## TYPE III LAND USE RECOMMENDATION

### Staff Report and Decision

**FILE NO.:** CP 11-01: Master Plan  
DP 11-03: Detailed Development Plan  
NR 11-05: Natural Resource Overlay Exemption  
LL 11-07: Lot Line Adjustment

**REQUEST:** The applicant submitted a Concept (General) Development Plan, Detailed Development Plan, Lot Line Adjustment and Natural Resource Overlay District Exemption to analyze the build out of the Providence Willamette Falls Hospital over the next 10 years and construct a parking lot.

FIGURE 3.1.1 - New Front Entry Street Improvements

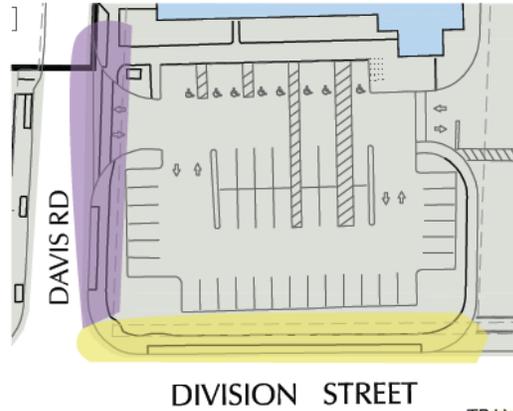
The New Front Entry project in Phase 2 would trigger applicable street improvements in the highlighted areas in Figure 3.1.1. Minor Arterial street improvements along Division Street (to match the improvements in front of the ED expansion detailed in CU 03-03), and Local street improvement along Davis Road.

- Phase 2 (Front Entry Improvements): Dedication to result in 26.5 feet of ROW on the southern side. Construction of pavement restoration as determined by Applicant's Engineer's analysis/design (and coordination with City's Pavement Condition Index at time of design). Construction of 2.5-foot wide full depth pavement restoration adjacent to new curb and gutter, 4.5-foot planter strip with street trees, 5 ft sidewalk, and street lighting.

FIGURE 3.1.2 - Birthplace Expansion Street Improvements

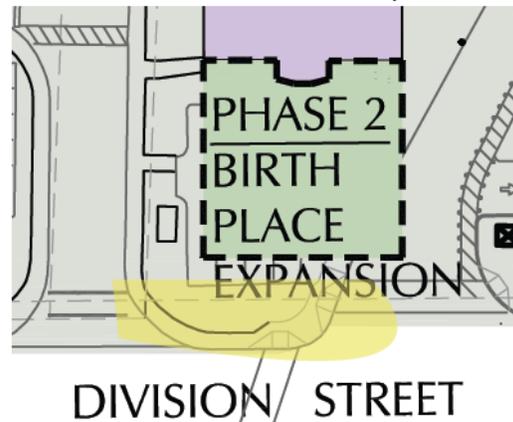
The Birthplace Expansion project in Phase 2 would trigger applicable street improvements in the highlighted areas in Figure 3.1.2. Minor Arterial street improvements along Division Street to match the improvements in front of the ED expansion detailed in CU 03-03.

FIGURE 3.1.3 - West MOB Street Improvements

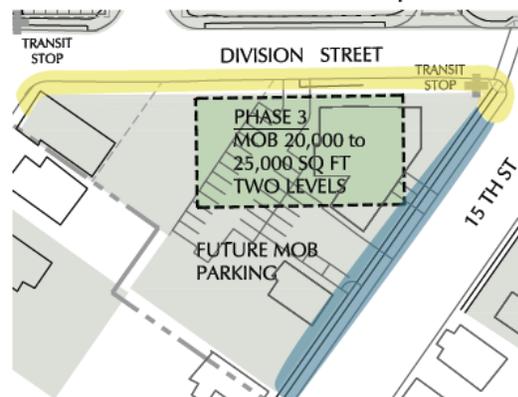
The West MOB project in Phase 3 would trigger applicable street improvements in the highlighted areas in Figure 3.1.3. Minor Arterial street improvements along Division Street (to match the improvements in front of the ED expansion detailed in CU 03-03), and Collector street improvement along 15th St. The improvements along Division St. will require a full depth half street improvements.

- Phase 3 (West MOB): A 4-foot ROW dedication from 15<sup>th</sup> Street to 16<sup>th</sup> Street to provide 34 feet from centerline on the west side. Construction of full depth pavement restoration between 15<sup>th</sup> Street and 16<sup>th</sup> Street for a width of 26 feet on the western half and 10 feet on the opposing side (if not completed by other phases). Construction of curb and gutter, 8 ft sidewalk with 4- by 6-ft tree wells, bike lane striping and markings, street lighting, and street trees.

- 15<sup>th</sup> Street, a Collector, would be improved with Phase 3 of the Master Plan as follows:
  - Phase 3 (West MOB): There is 38 feet of existing pavement, with 19 feet on the MOB side. Construction of pavement restoration as determined by applicant's engineer's analysis/design (and coordination with City's Pavement Condition Index at time of design) across the tax lot frontages for a width of 19 feet on the northern half and 10 feet on the opposing side. Evaluation of the existing street lighting and install as necessary to meet current IES. Installation of street trees in existing planter strip and bike route signs.
